UNIVERSITY OF VIRGINIA
DEPARTMENT OF NUCLEAR ENGINEERING AND ENGINEERING PHYSICS
NUCLEAR REACTOR FACILITY
SCHOOL OF ENGINEERING AND APPLIED SCIENCE
CHARLOTTESVILLE, VA 22901

Michael W. Jankowski
Accident Source Term Program Office
Office of Nuclear Regulatory Research
U. S. Nuclear Regulatory Commission
Washington, D. C. 20555

Preliminary Comments on the QUEST Study

Figure A-1 Tellurium release rates used in CORSOR.

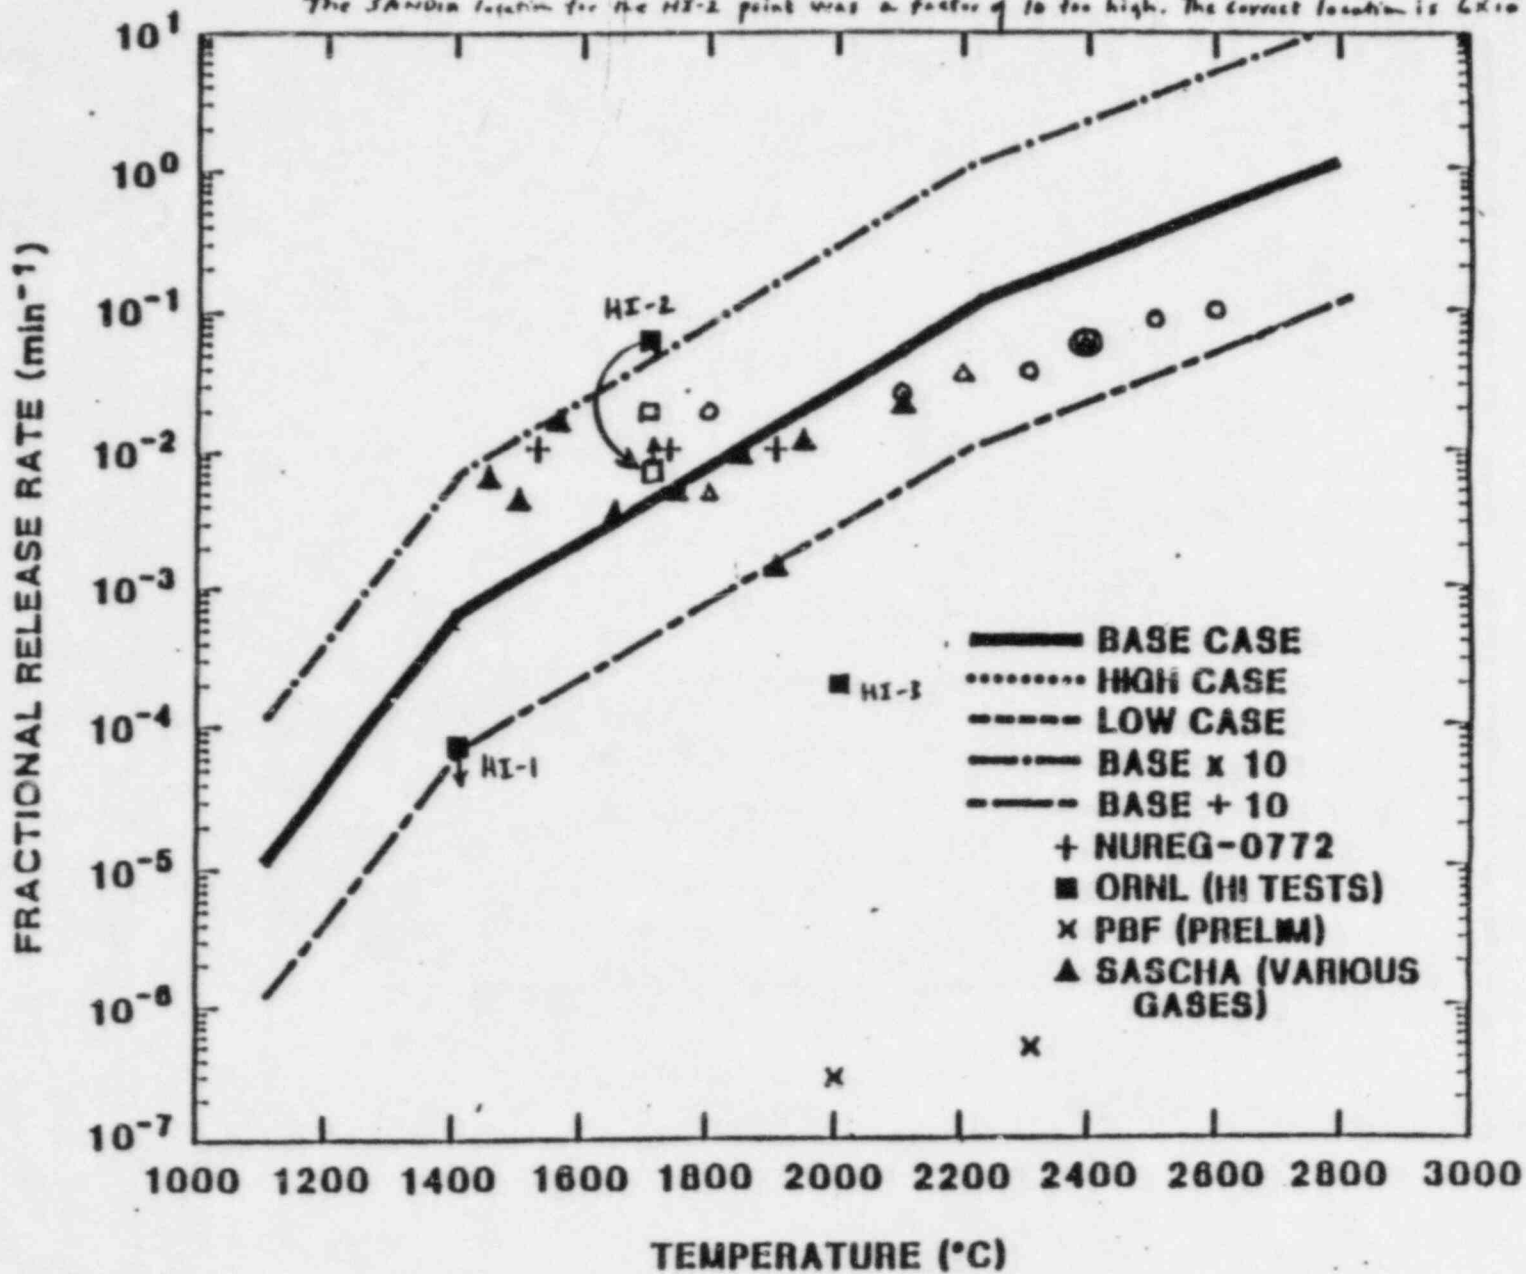
The first point to note is that I am perplexed as to where the data was obtained for the solid triangle (SASCHA) data points in Figure A-3. I have plotted the tellurium data points from the SASCHA tests, as noted

in red (open Δ , \square , and o's) on the next page, and they are totally different from the data in Fig. A-3. Also I believe there was a factor of 10 error in the plotting of the HI-2 datum. My understanding of the correct placement of this point is also shown on the next page. The NUREG-0772 curve for Te appears to be close to the upper limit of the release rates for the data as I have plotted them.

The SANDia location for the HI-2 point was a factor of 10 too high. The correct location is 6×10^{-3} at 1700°C .
